CERTIFICATE OF APPROPRIATENESS

Property: 1029 Arlington Street, Lot 4, Block 219, Houston Heights Subdivision. The property includes a historic 1,500 square foot, one-story wood frame single-family residence situated on a 6,600 square foot (50' x 132') interior lot.

Proposal: Alteration – Addition, Revision to COA approved by HAHC **5/22 HPO2022_0110**

2 COMBINED NEW WEST (BACK YARD) ELEVATION:
 WITH NEW ADDITION BEHIND ORIGINAL GABLE ROOF
 SCALE: 1/4" = 1'-0"

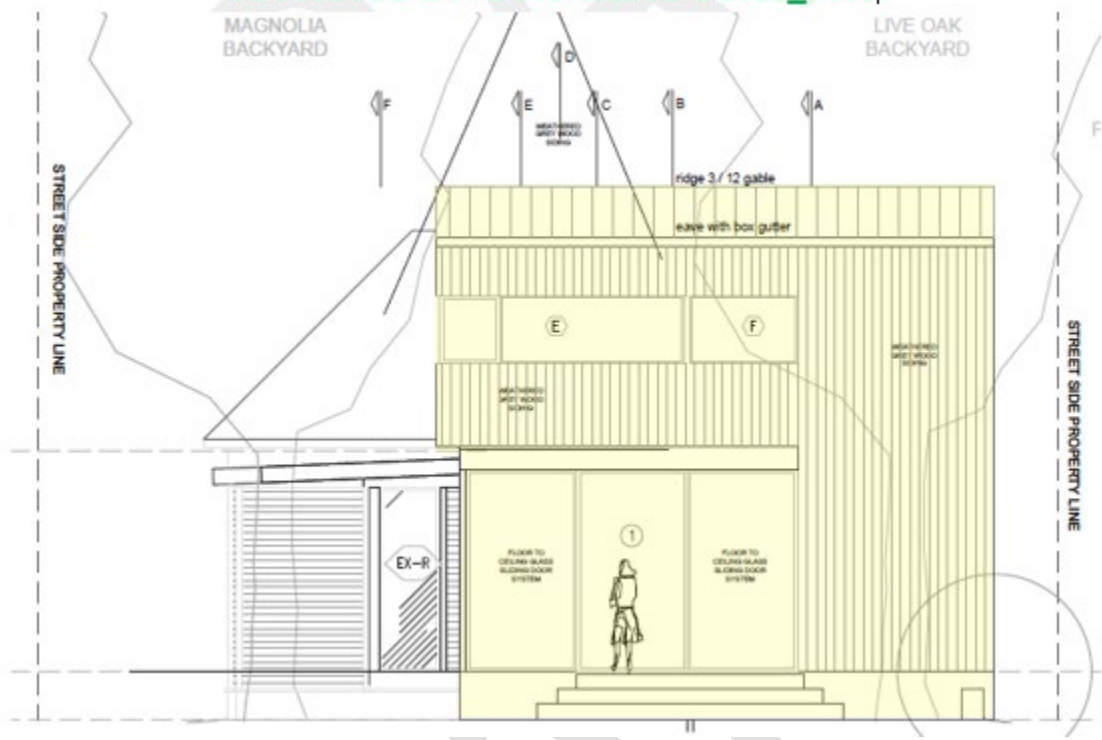
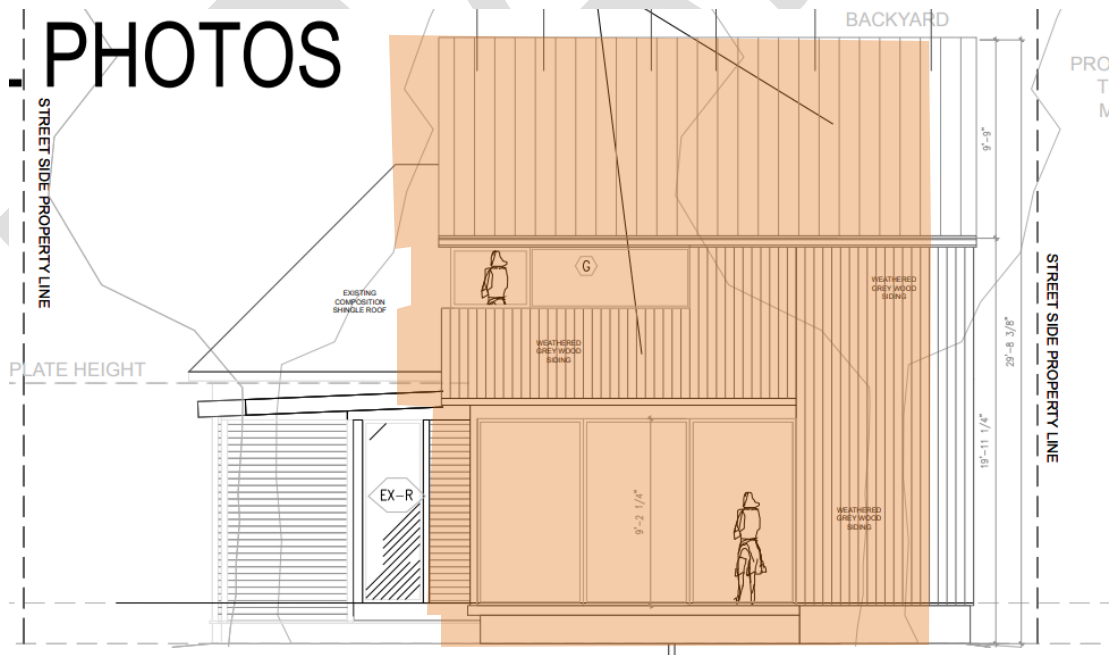
<i>Rear addition roof pitch is 12/12, while it matches the historic, it is not typical of additions on contributing buildings in the area and has a more pronounced form or profile. If the roof pitch was lowered, the addition would appear more recessive.</i> |

<i>Rear addition roof pitch is 12/12, while it matches the historic, it is not typical of additions on contributing buildings in the area and has a more pronounced massing and scale. If the roof pitch was lowered, the addition would appear more recessive.</i> |

Recommendation: Approval with conditions: Lower roof pitch and work with staff on pitch of final design.

2 ORIGINAL NORTH (SIDE YARD) ELEVATION:
 WITH NEW ADDITION BEHIND ORIGINAL GABLE ROOF
 SCALE: 1/4" = 1'-0"

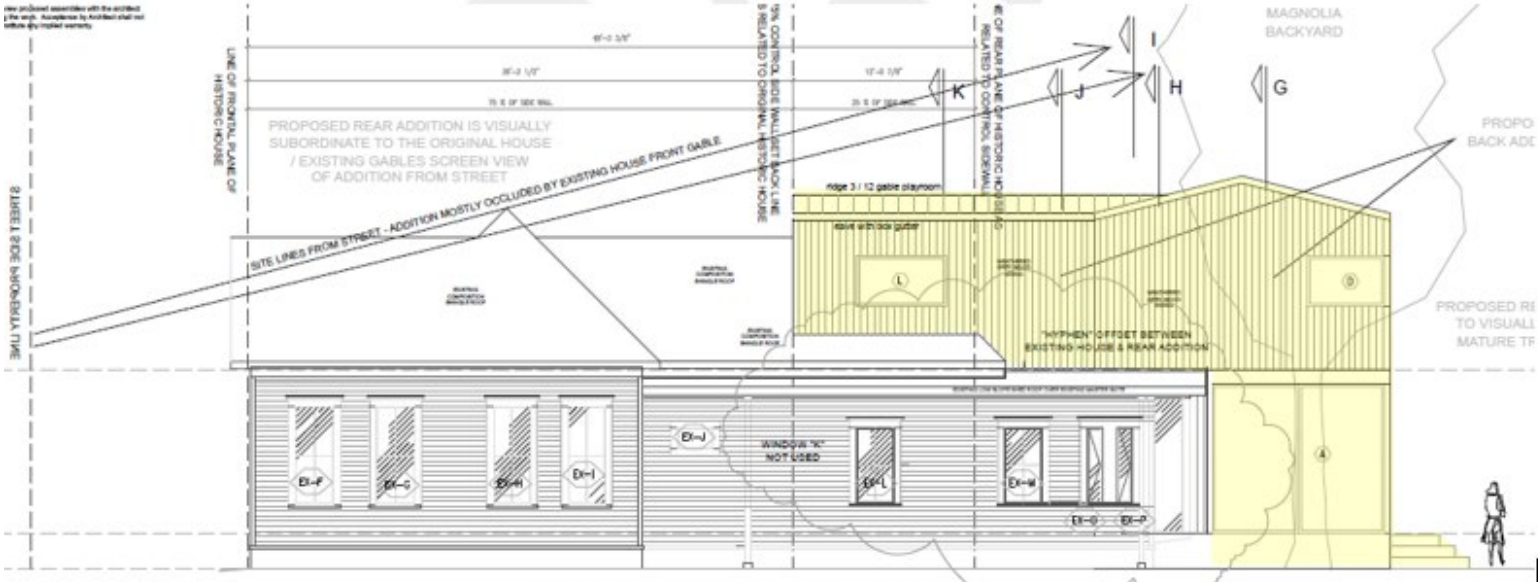
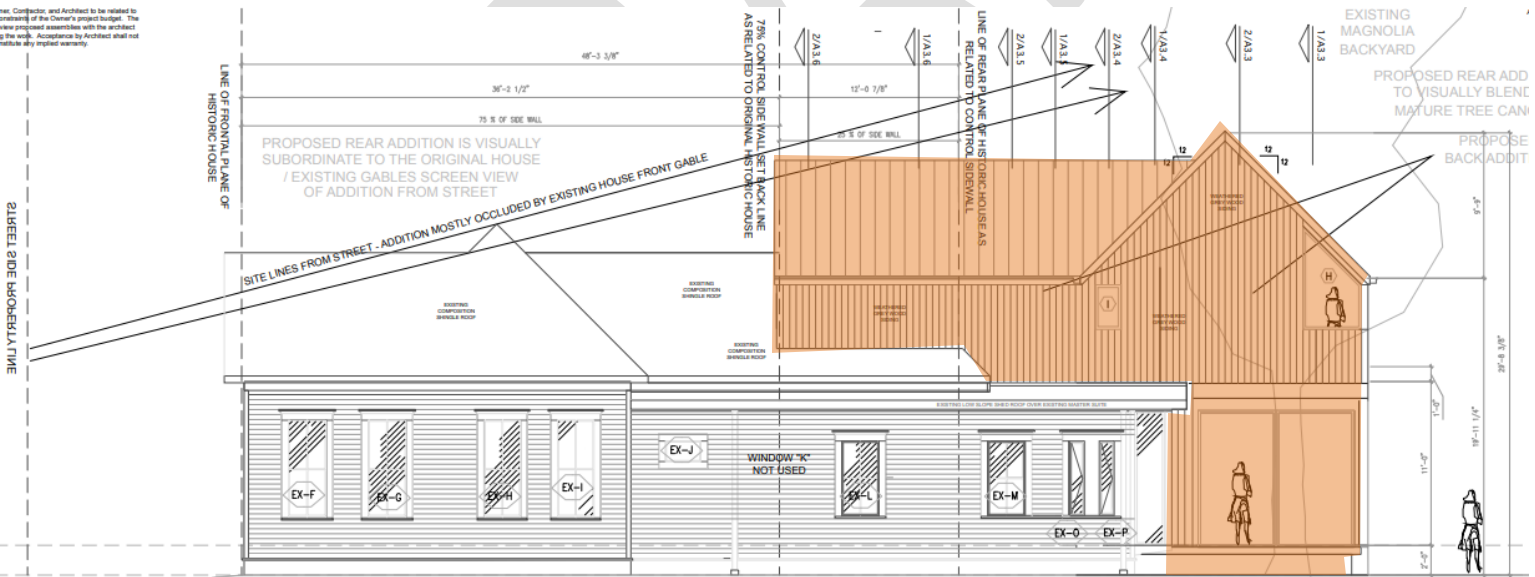
I have a graphic mistake on the north side: the two windows shown close together that you have highlighted = that is incorrect: there is only the one existing unit to the right, highlighted. The "original house" graphic is imported from the 2012 bathroom room project & in reality the builder for that project did NOT add that window in, which would have gone into the new master closet. So the graphic showing the addition is the one that actually has the correct graphic for the existing windows on that north wall.....
